**RE: 1341 Flightway Ave. SE**  
**Grading and Drainage Plan**  
**Engineer's Stamp Date: 10/10/23**  
**Hydrology File: M15D023A**

Based upon the information provided in your submittal received 10/11/2023, the Grading & Drainage Plan is approved for Building Permit and Grading Permit. Please attach a copy of this approved plan in the construction sets for Building Permit processing along with a copy of this letter.

PROJECT NAME:  
GARCIA & GARCIA  
AIR CARGO TRANSPORT  
1341 FLIGHTWAY AVE.  
ALBUQUERQUE, NM 87106

SHEET TITLE:  
GRADING AND  
DRAINAGE PLAN

SHEET NO:  
C - 1

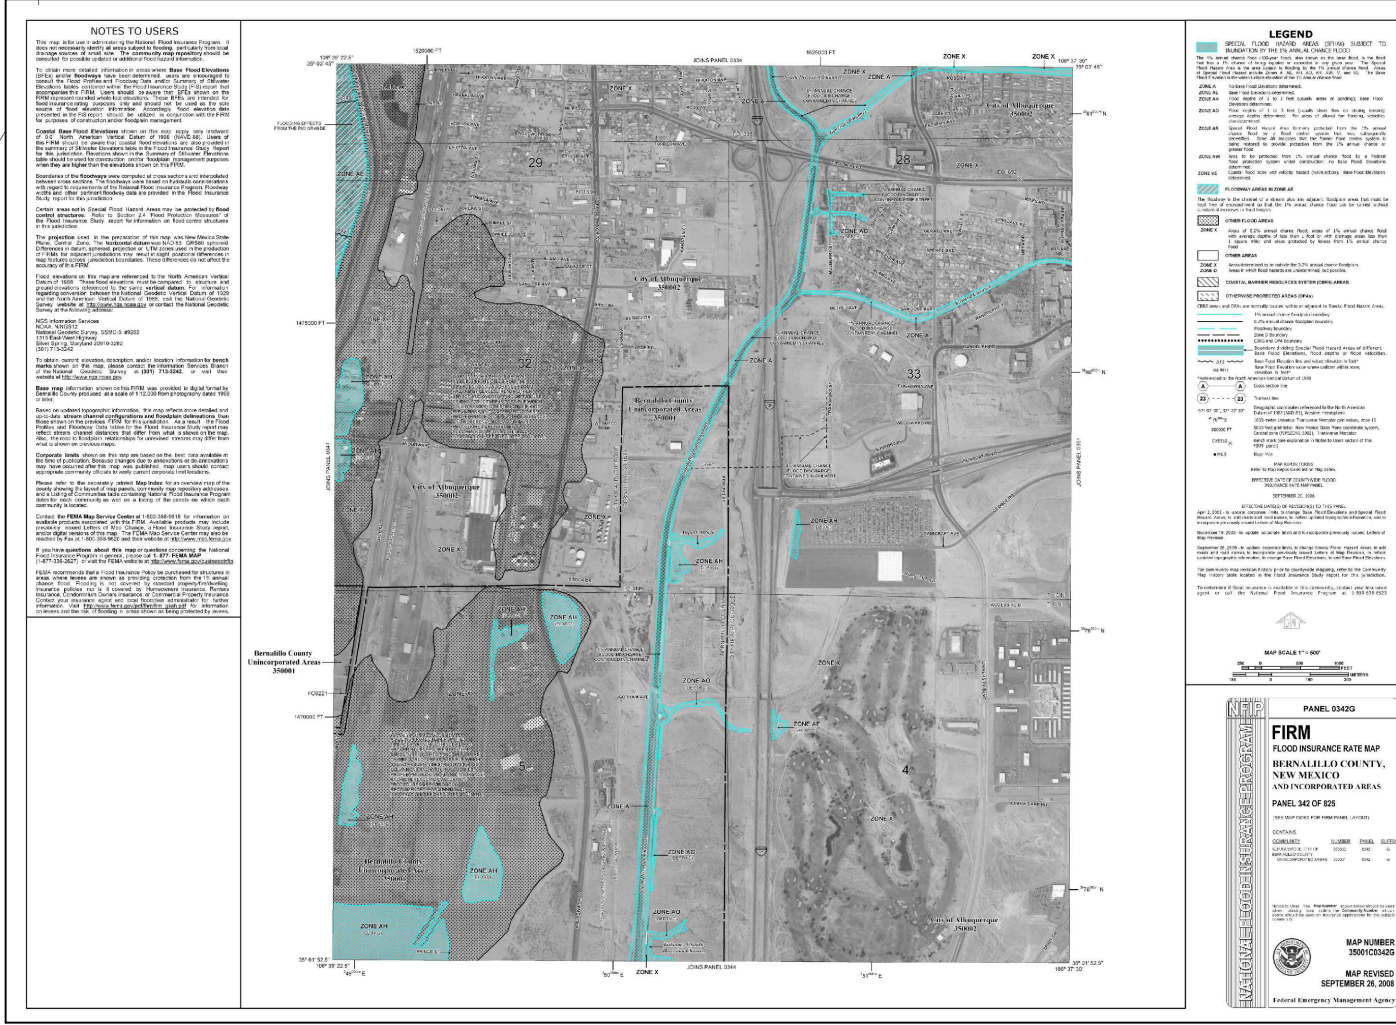
**PRIOR TO CERTIFICATE OF OCCUPANCY:**

1. Engineer's Certification, per the DPM Part 6-14 (F): *Engineer's Certification Checklist For Non-Subdivision* is required.
2. Please provide the executed paper Drainage Covenant (latest revision) printed on one-side only with Exhibit A and a check for **\$25.00** made out to "**Bernalillo County**" for the stormwater quality pond per Article 6-15(C) of the DPM to Hydrology for review at Plaza de Sol.
